## PRODUCT SUPPORT BULLETIN BULLETIN NO. 364

MACHINE: **Model M2 Ballast Regulator/Snow Clearing Machine**

SUBJECT: **Replacement Steel Fan on Machines with Cummins Engines**

**Steel Cummins Engine Fan B-3300-6**

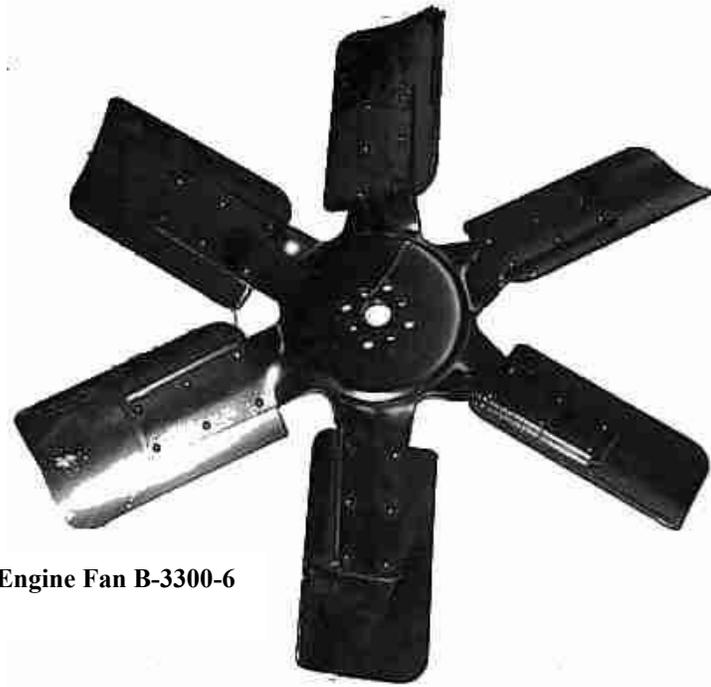
The engines on these machines were originally equipped with an aluminum radiator fan, p/n B-33300-1. These fans are subject to abrasive wear from dust blown up during machine operation and have a relatively short life.

To correct this problem, a **Steel Fan, p/n B-33300-6** is available as a direct replacement for the aluminum fan. This fan will have an increased service life when compared to the aluminum fan and is a direct replacement.
